ADDENDUM NO. 1

ROWE
Federal Aid Project No. STP(BR-OFF)-003S(739)X
Superstructure Replacement, R-10-008, Cyrus Stage Road over Potter Brook

ROWE
Federal Aid Project No. STP(BR-OFF)-003S(739)X
Superstructure Replacement, R-10-008, Cyrus Stage Road over Potter Brook
(Proposal No. 608855-126249)

Questions and Responses

SUBSTRUCTURE DETAILS - 1

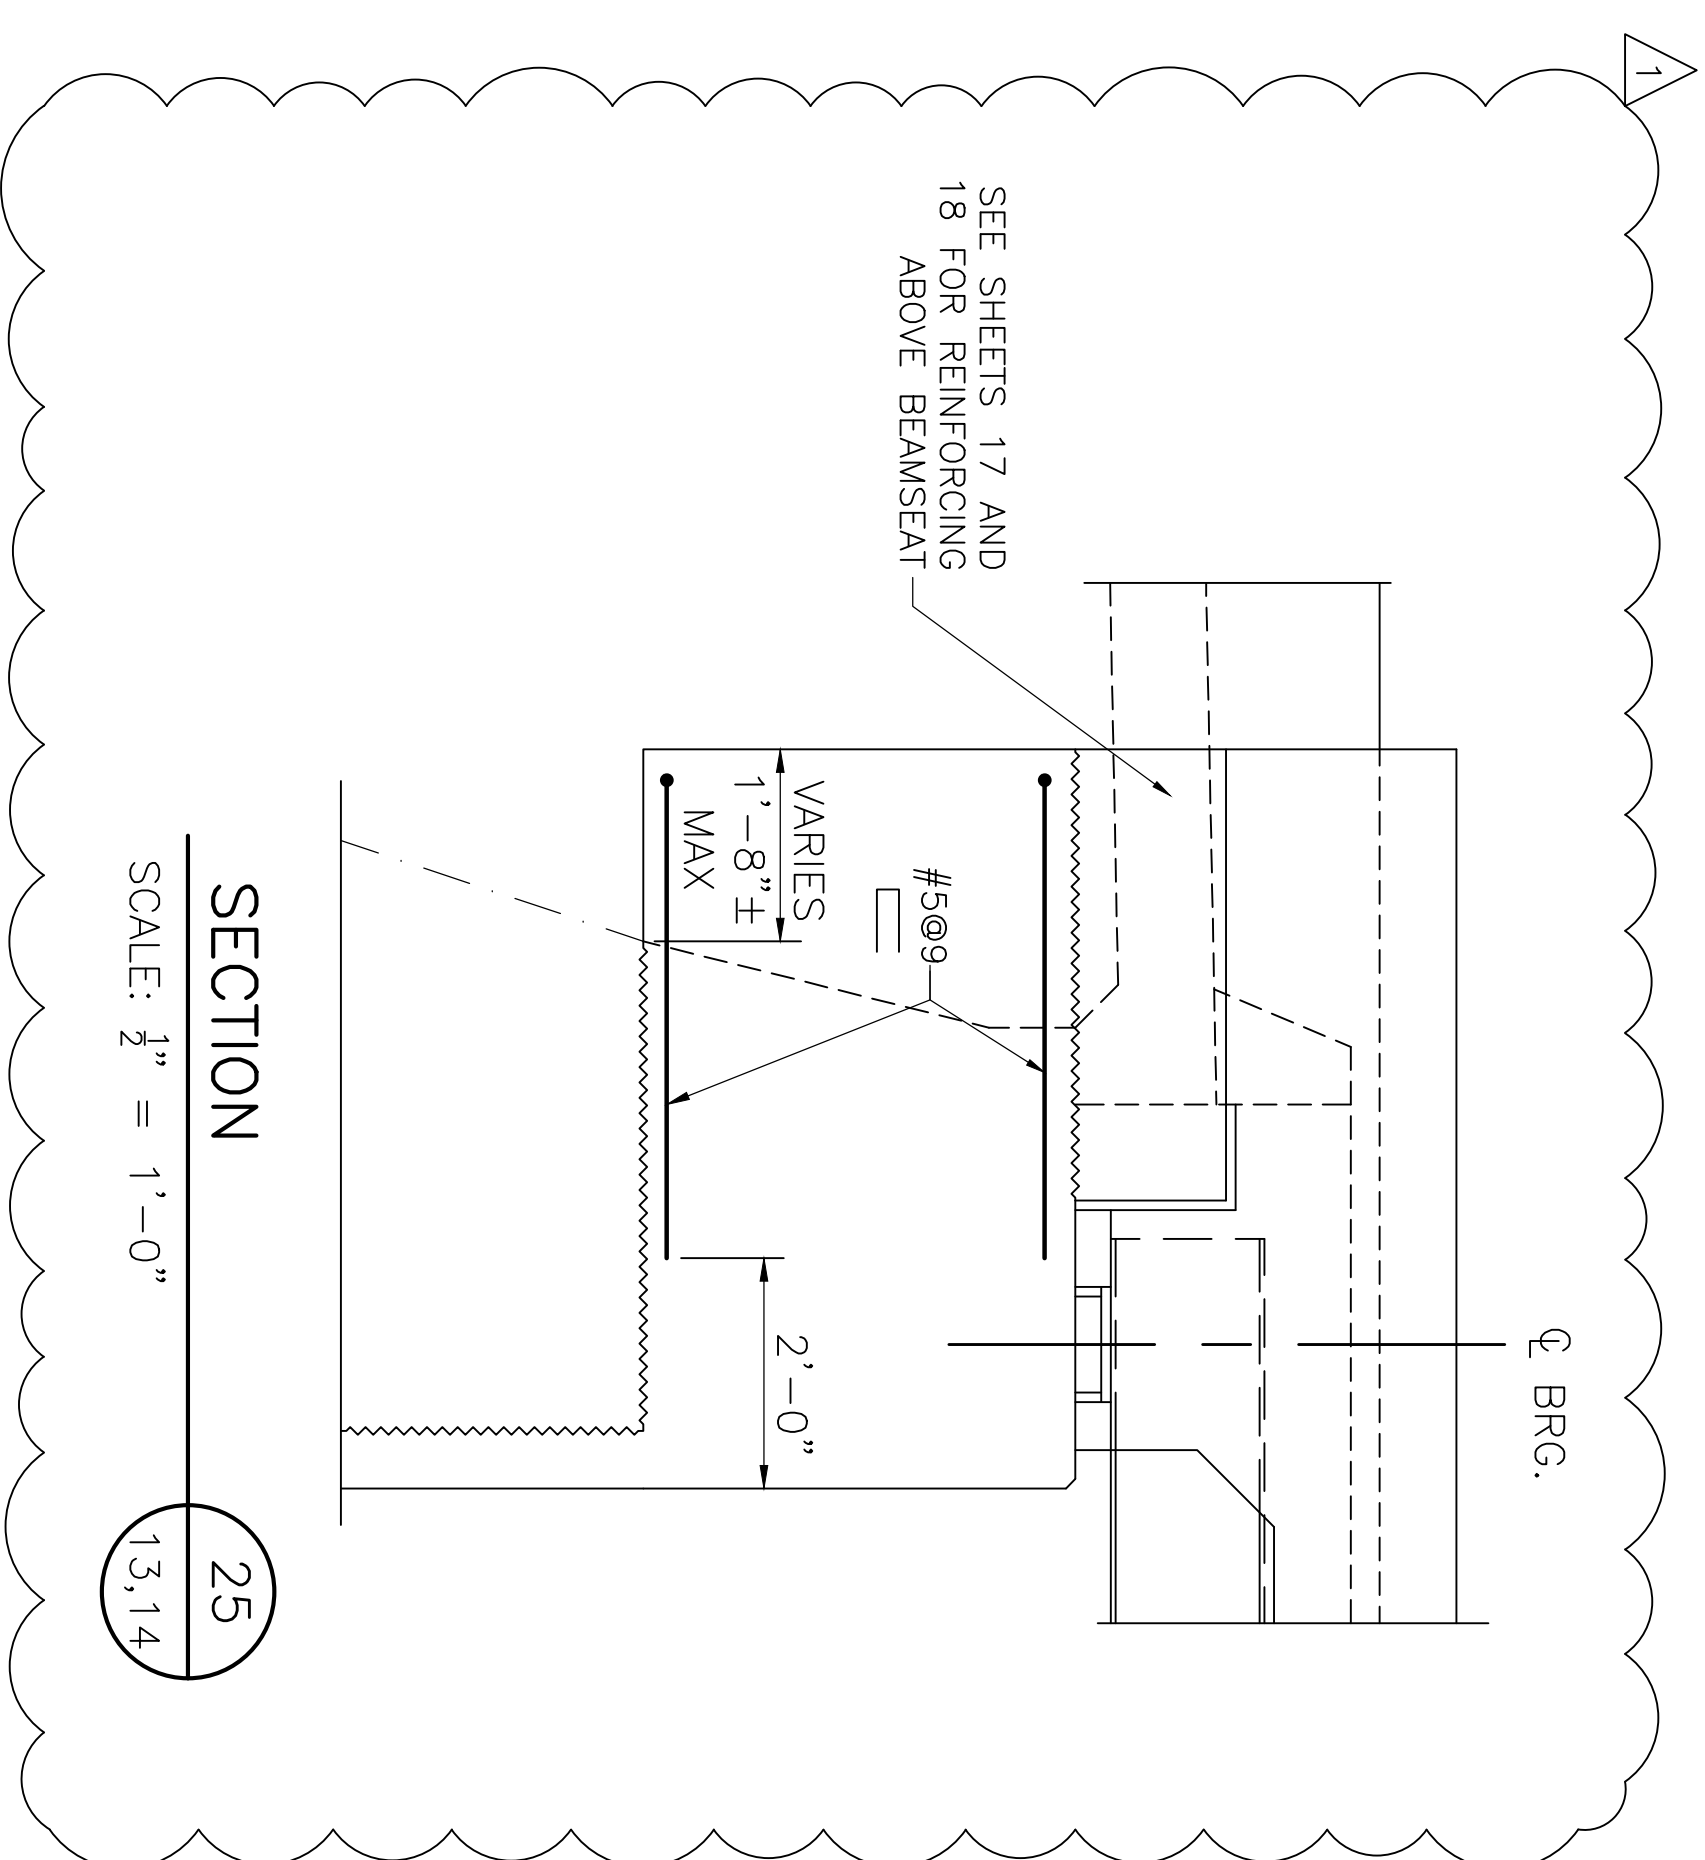
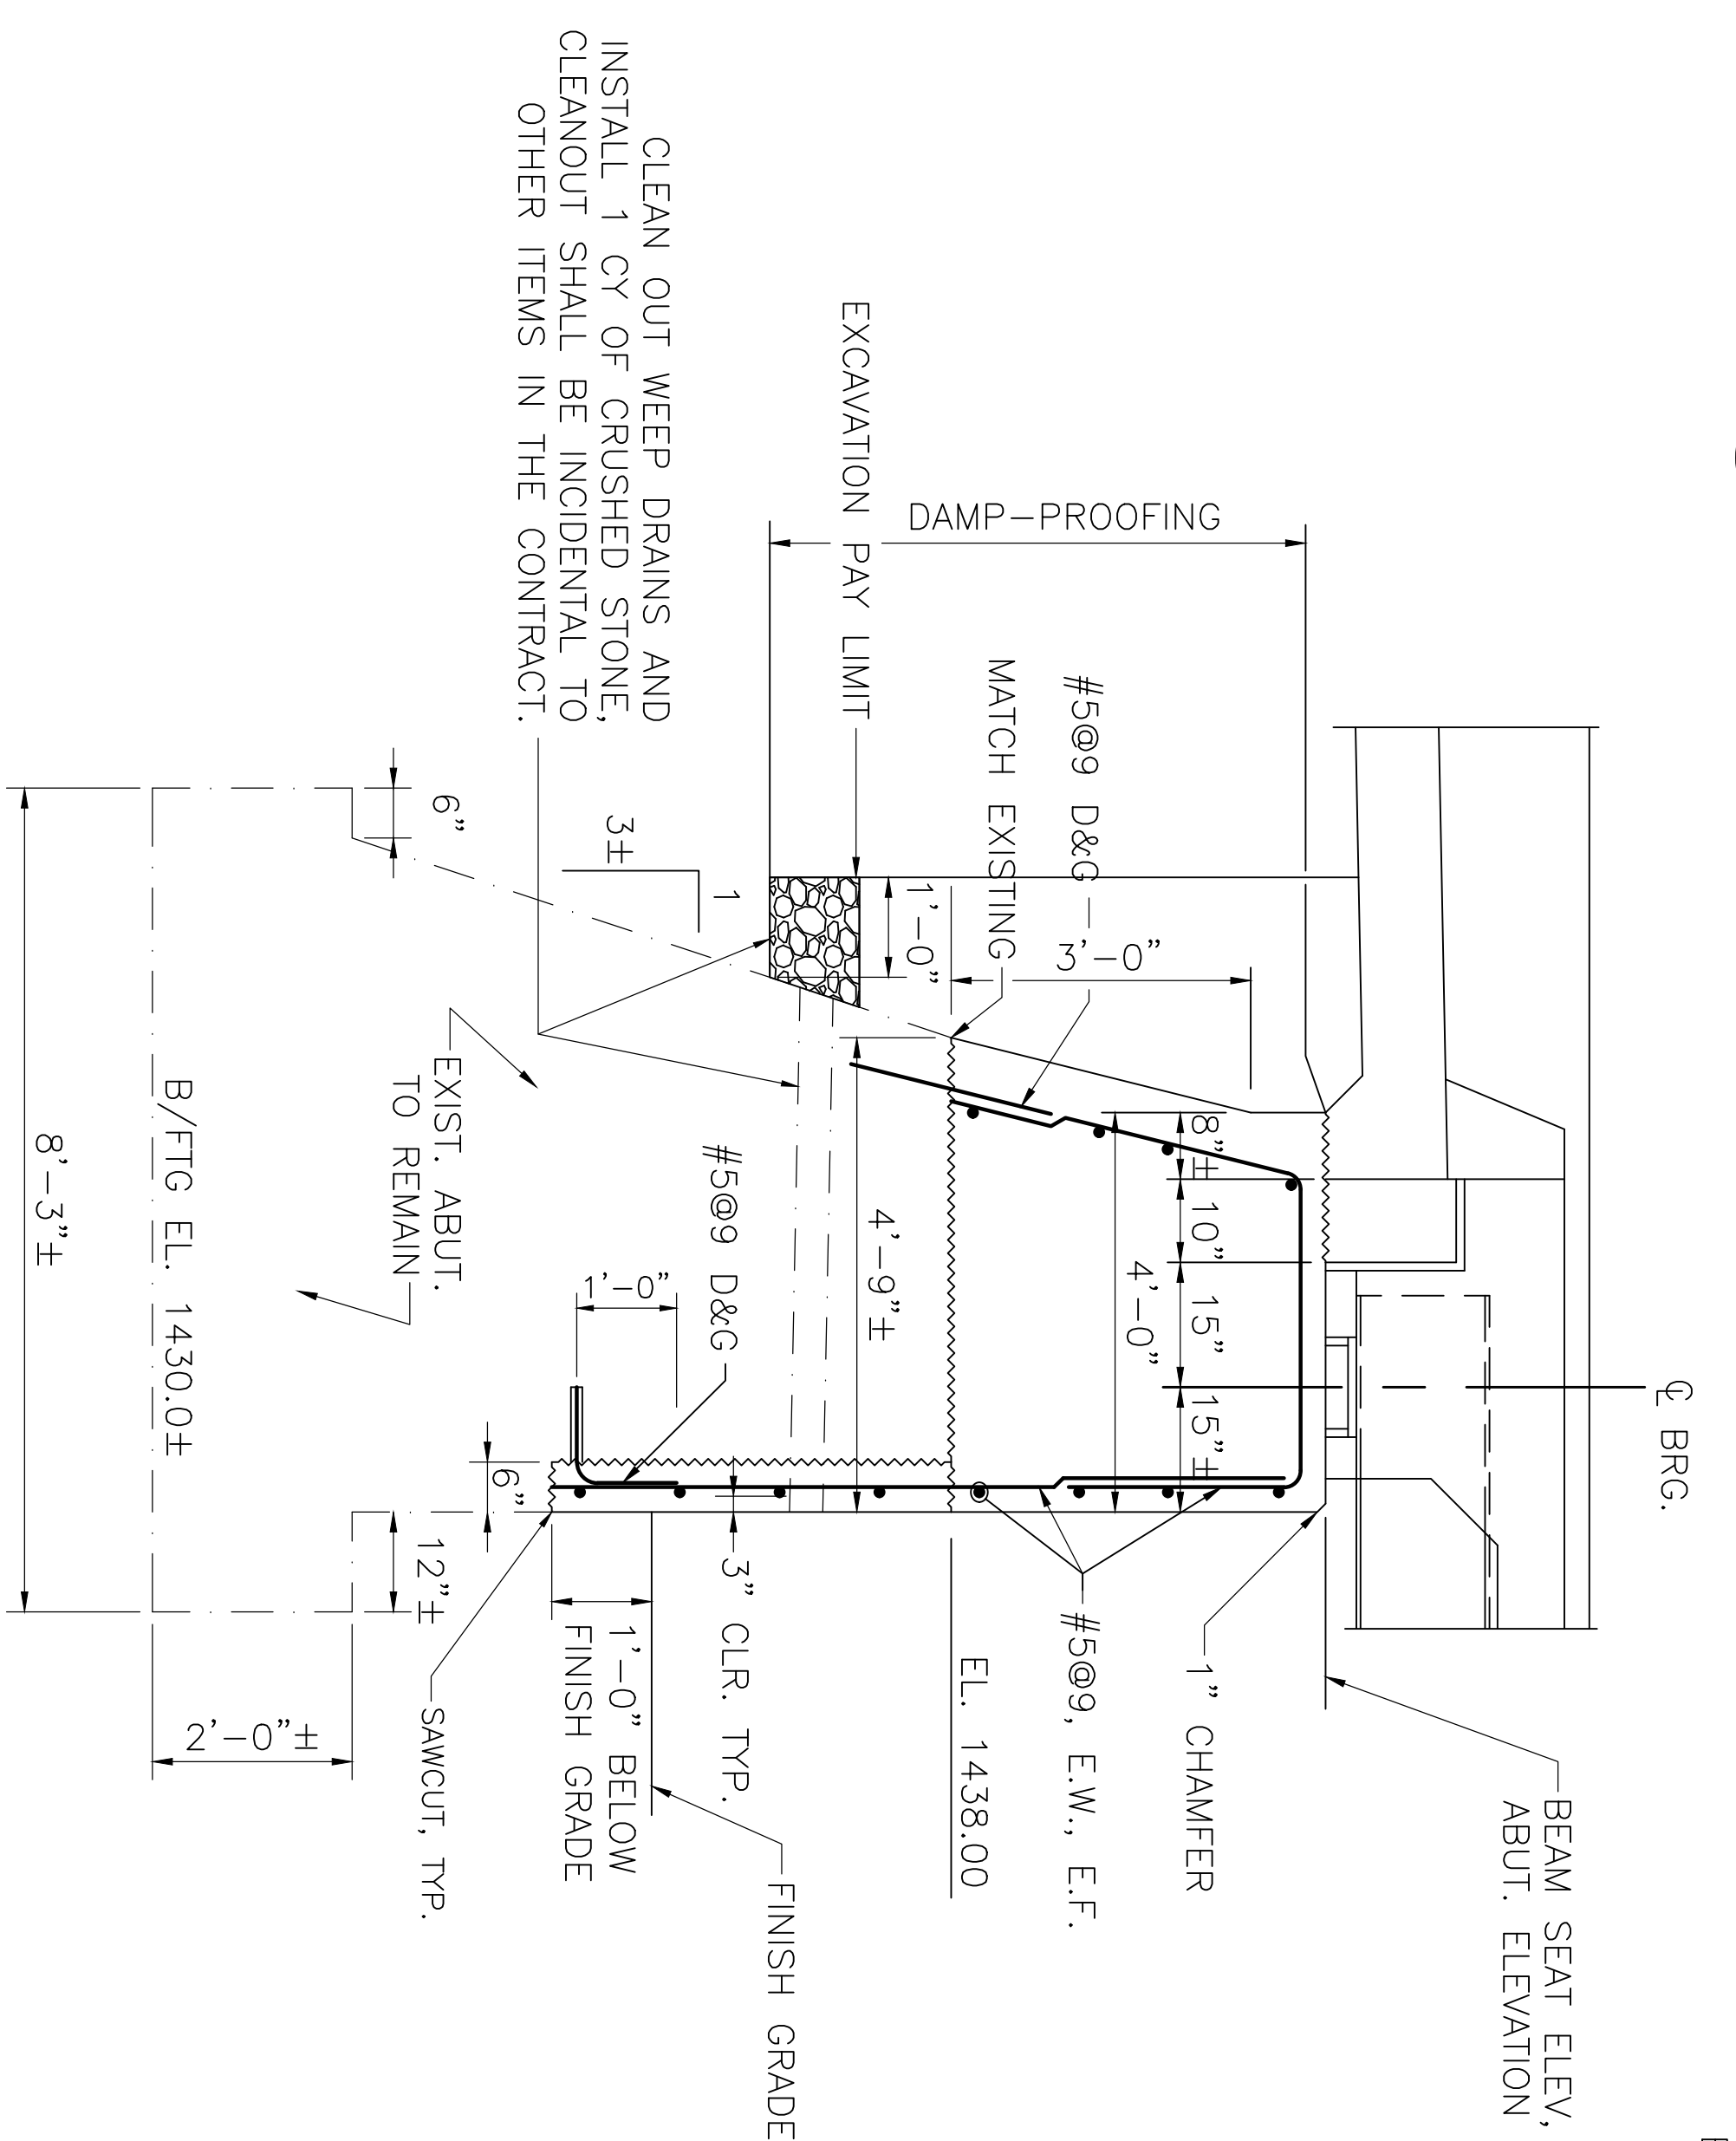
Question 3) Please refer to sheet 13 of 25 of the bridge drawings. It appears that the proposed precast highway guardrail transitions are going to conflict with the existing abutment sections that are to remain. Please provide additional details regarding these proposed guardrail transitions and how they will tie-in to the existing abutment.

- Question 4) Please refer to sheet 23 of 25 of the bridge drawings, detail: “Precast Guardrail Transition Plan at NW, SW, and NE Corners.” It doesn’t appear that this detail matches the curtain wall layouts shown on the abutment drawings, particularly on the SW and NE Corners. At the SW and NE Corners, it appears the curtain walls extend beyond the limits of the existing abutment at the demolition limit. Please clarify and provide further details on these curtain walls.
- Response 4) See revised Plan Set Sheets Nos. 29, 30, and 31 of 50.

Response 3) See revised Plan Set Sheets Nos. 29, 30, and 31 of 50.

DATE	DESCRIPTION
7/10/2024	SECTION 25 ADDED
6/8/2024	ISSUED FOR CONSTRUCTION
